ADDENDUM NO. 1

PROJECT NAME: Wick Alumni Center Life Safety & HVAC Improvements
UNL PROJECT NUMBER: C120P021
BID INVITATION NUMBER: 2222-13-7200

CONSULTANT: Farris Engineering
ADDRESS: 818 P Street, Suite 100

DATE OF ISSUANCE: September 3, 2013
DATE OF BID OPENING: September 18, 2013

SHEET TITLE
SECOND AND THIRD FLOOR HVAC PLANS

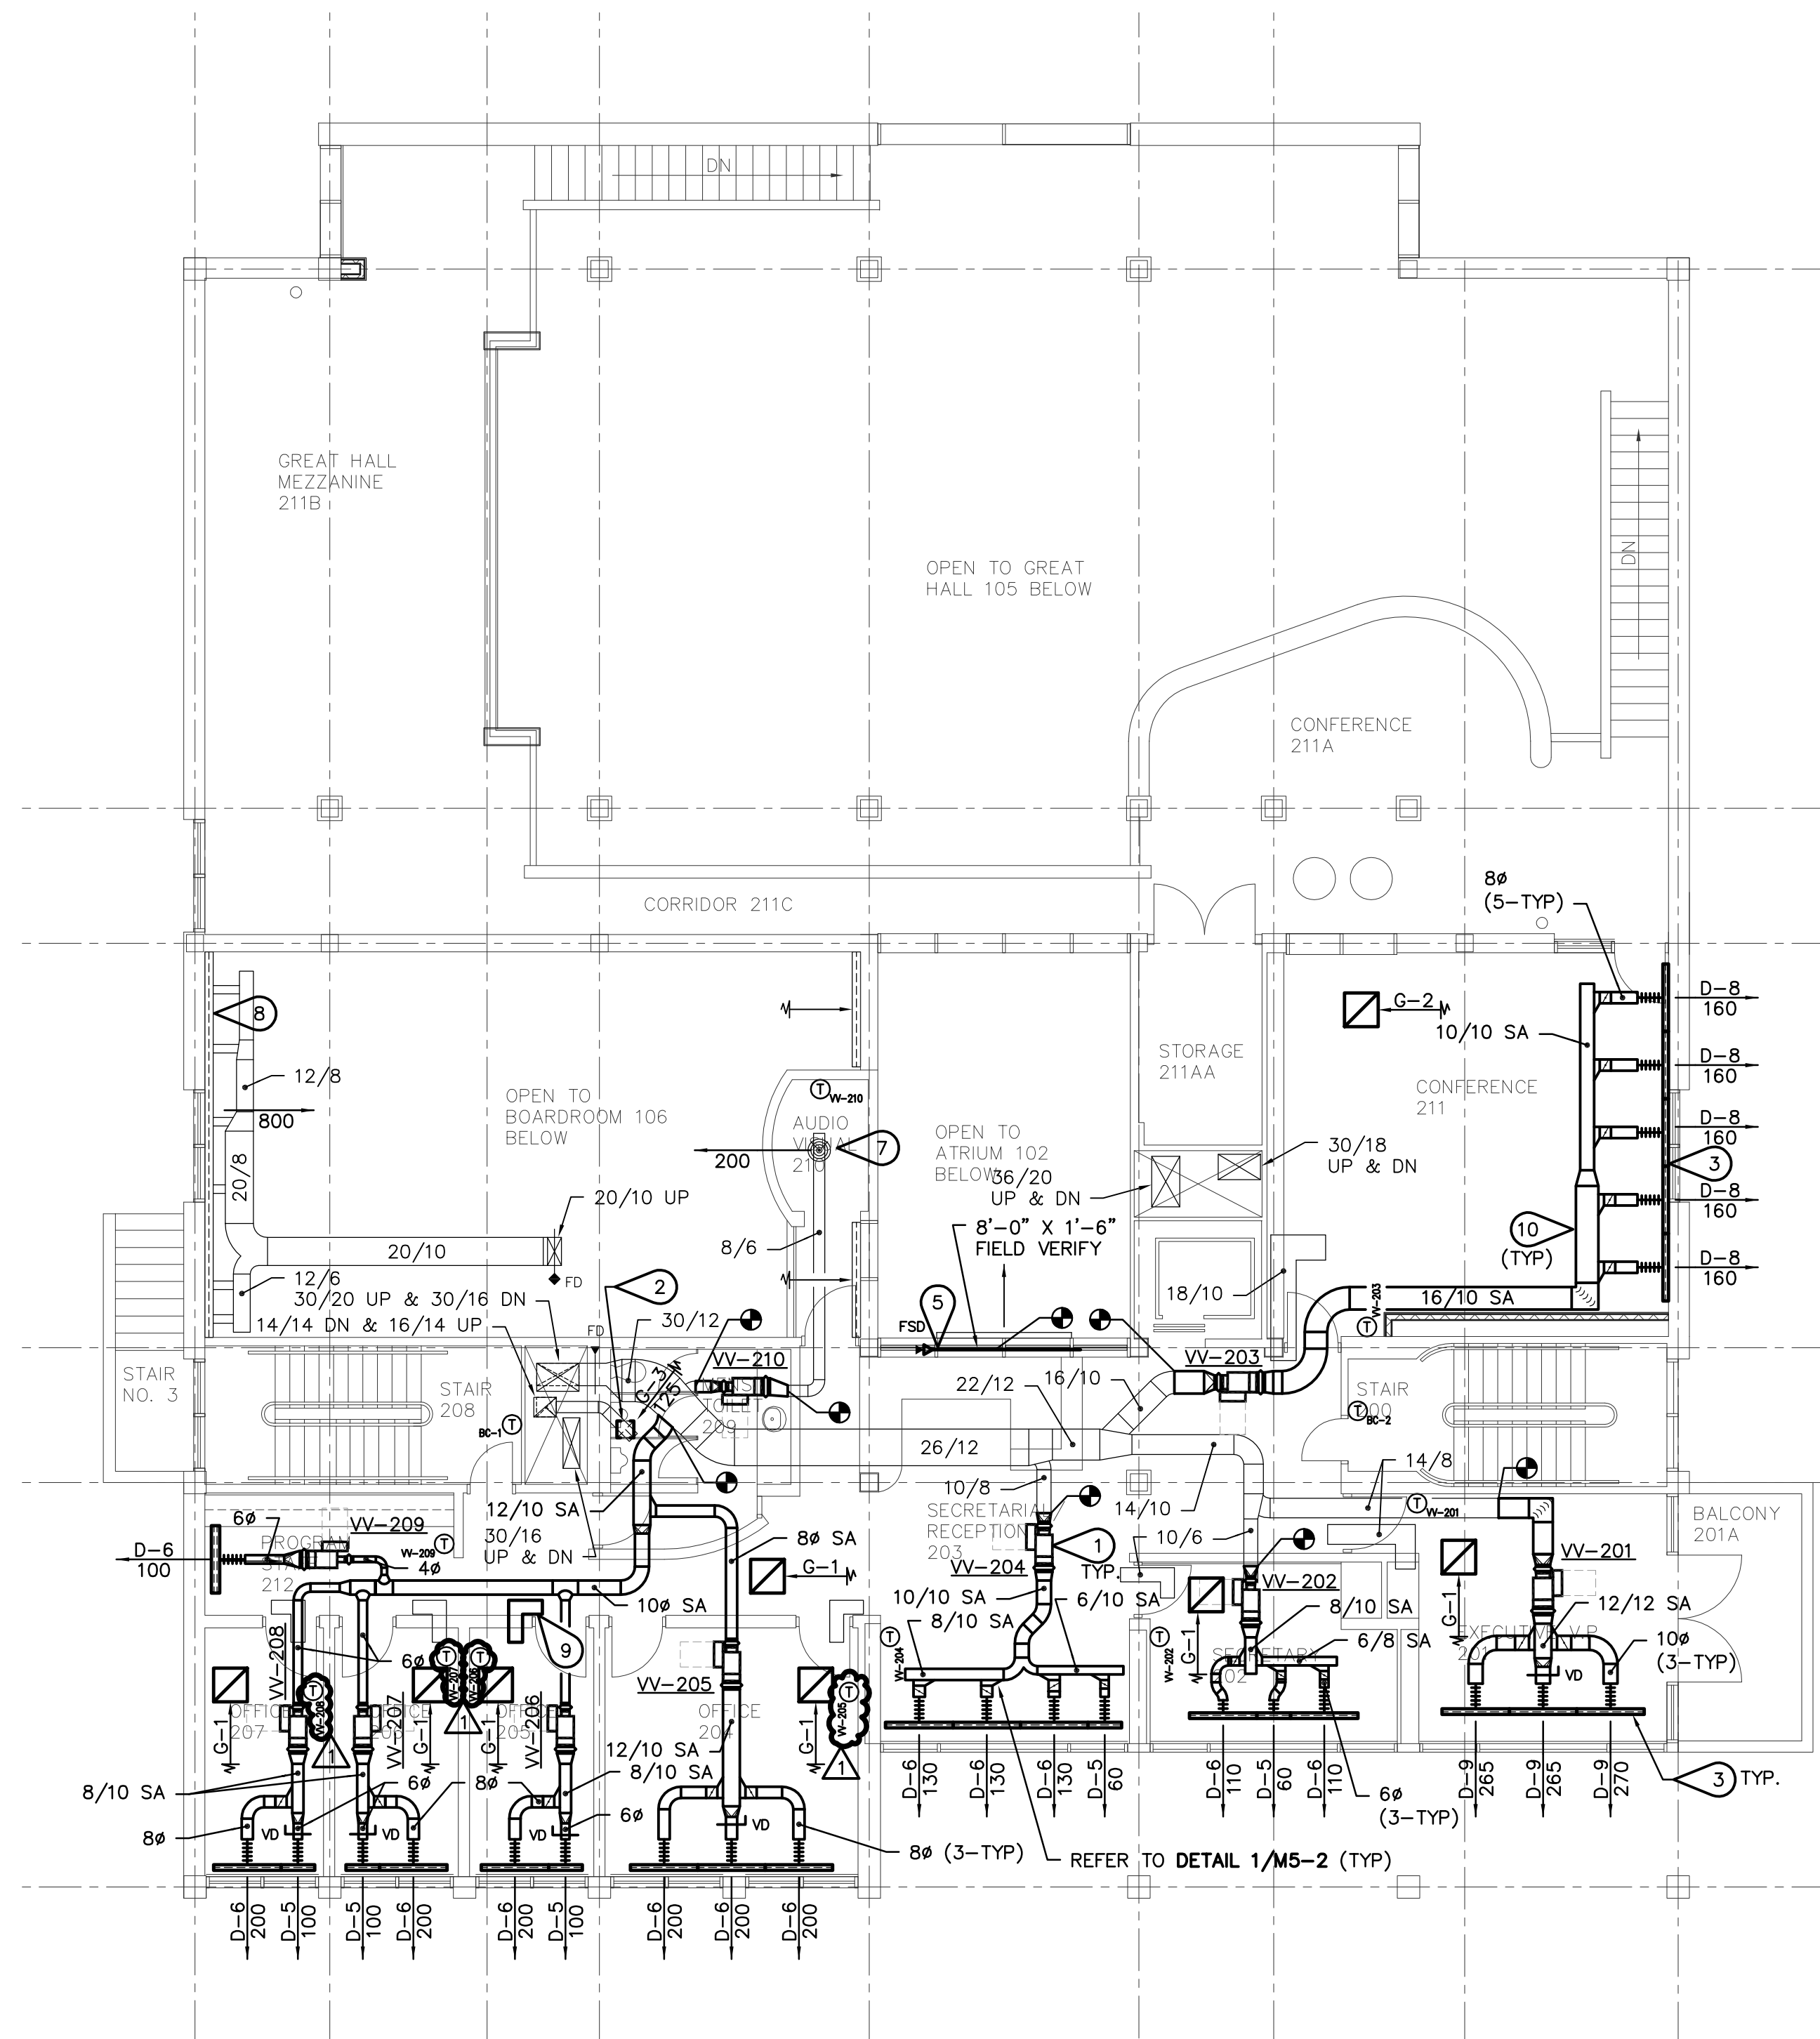
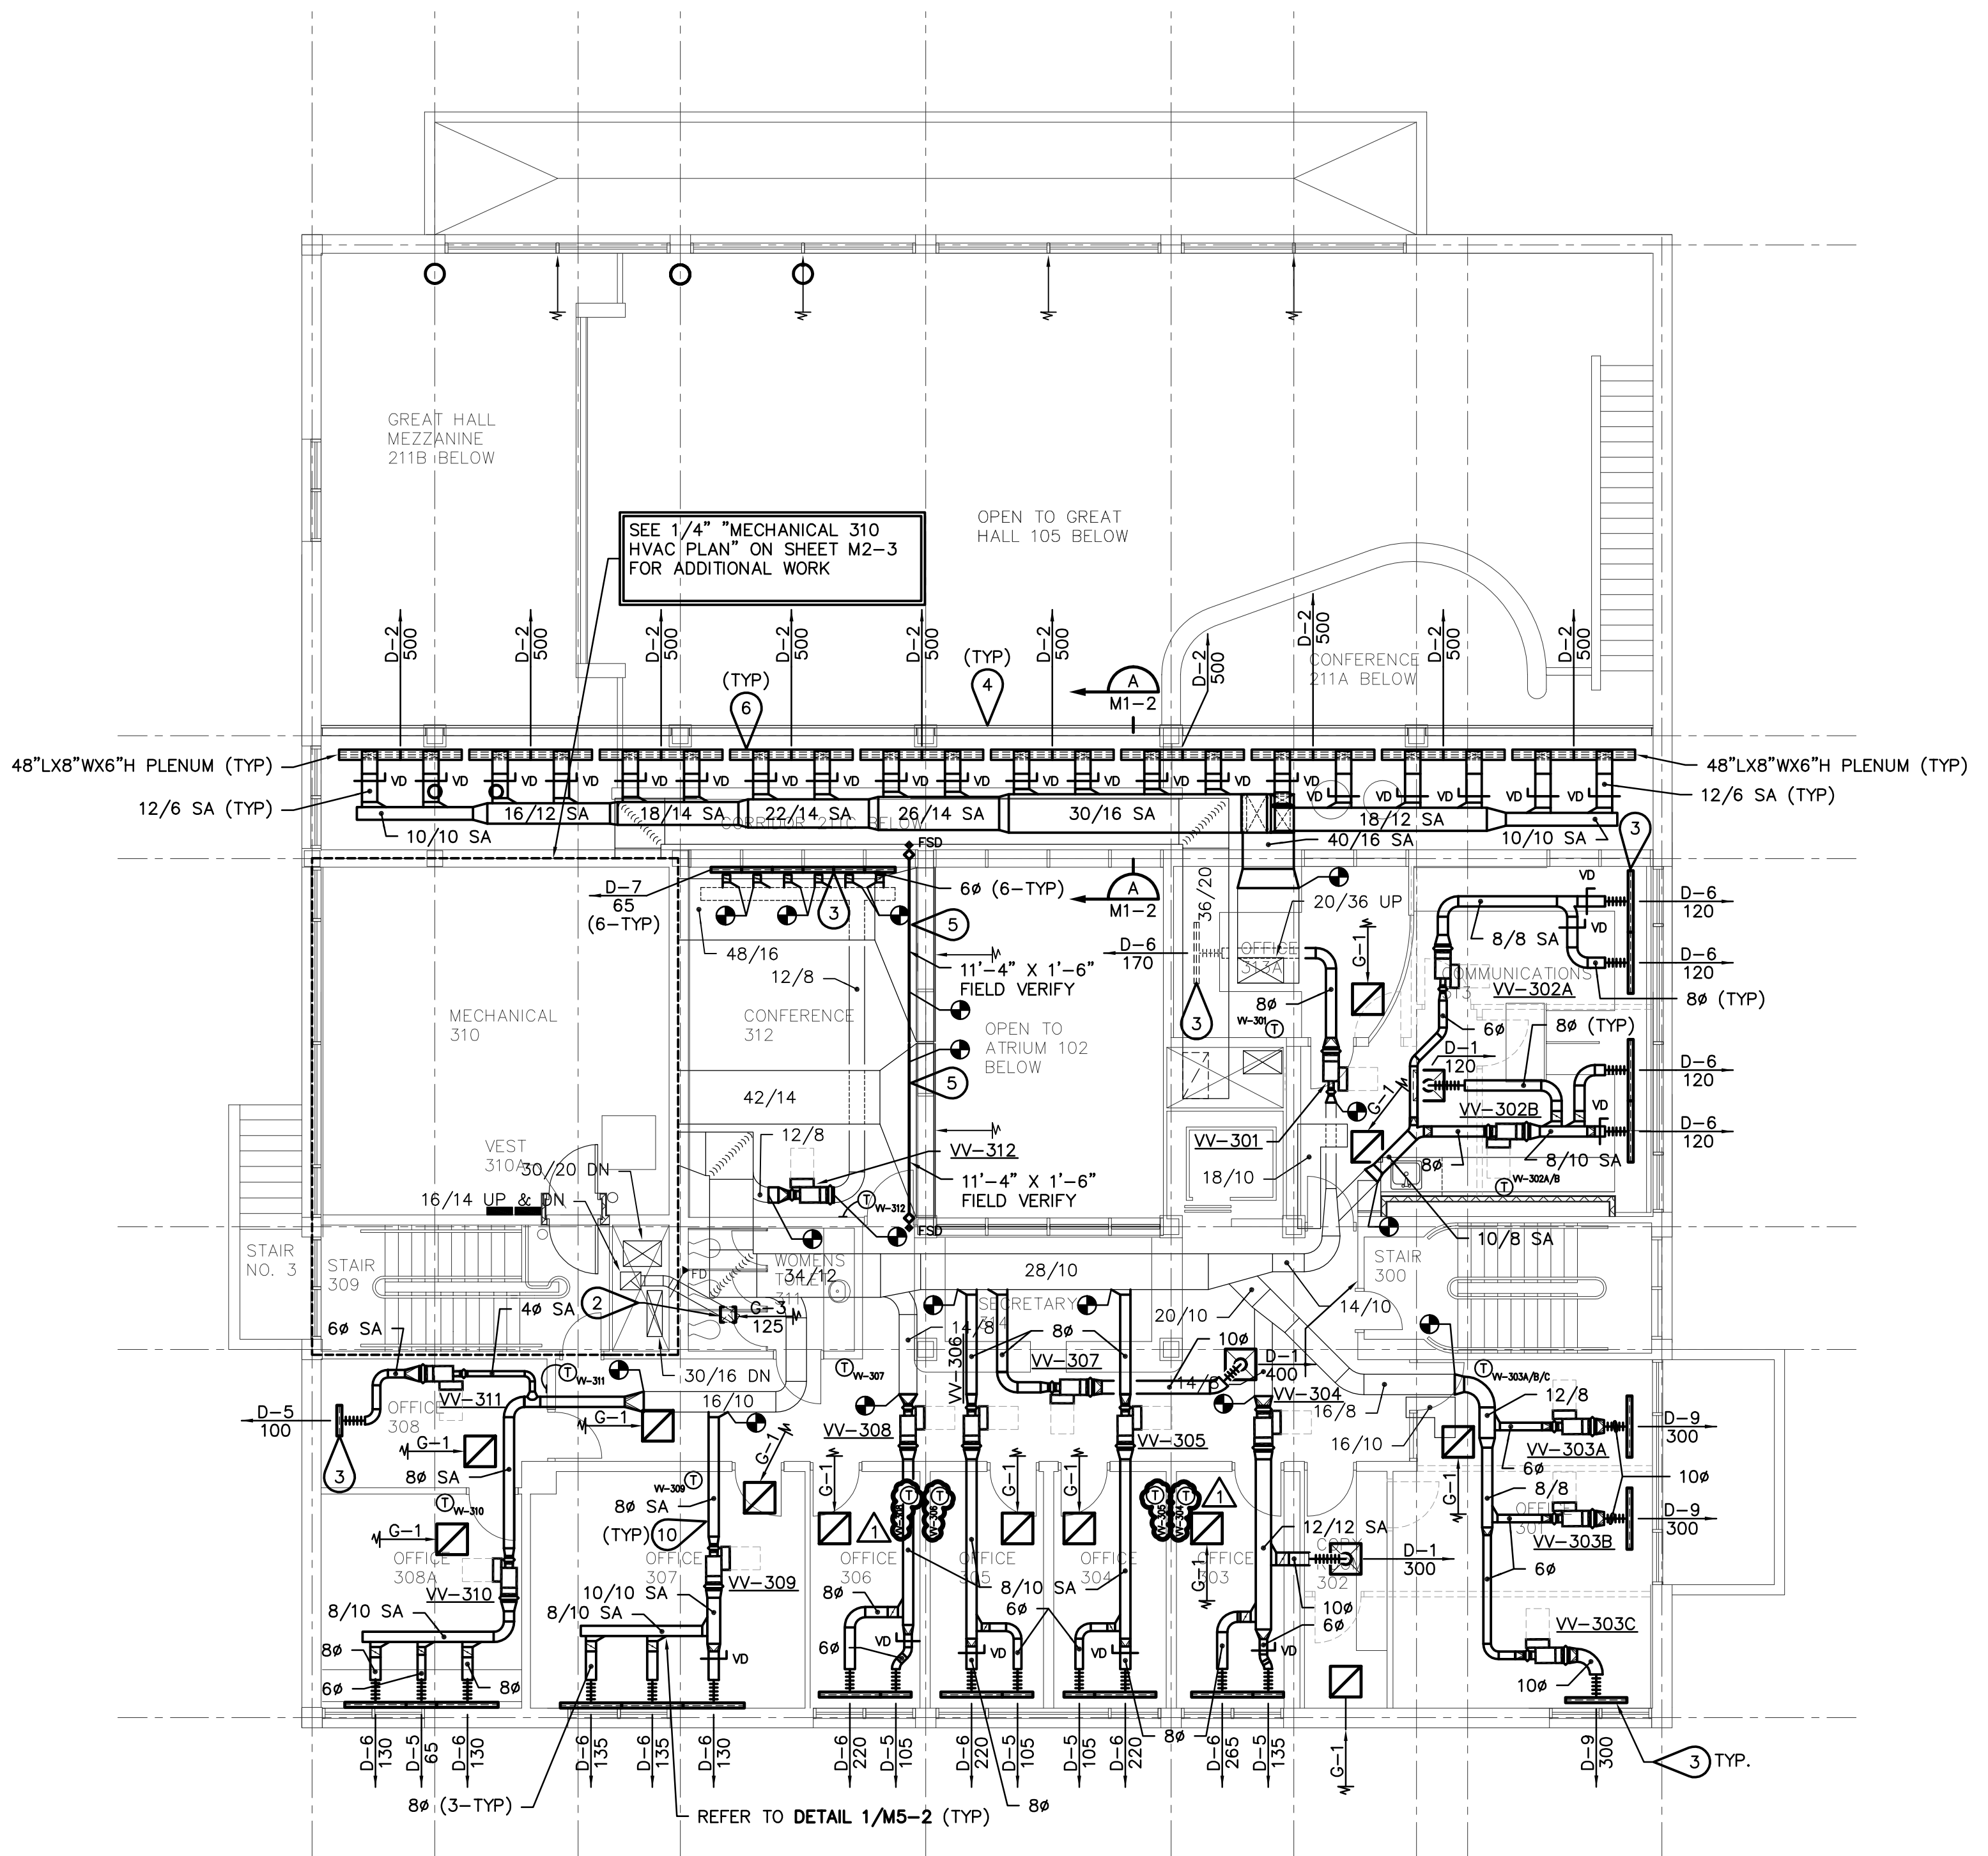
11. SHEET M1-2, SECOND AND THIRD FLOOR HVAC PLANS:
 - A. This sheet has been reissued in its entirety as a part of Addendum No.1.
 - B. Thermostats have been relocated in Rooms 204, 205, 206, 207, 303, 304, 305, 306.
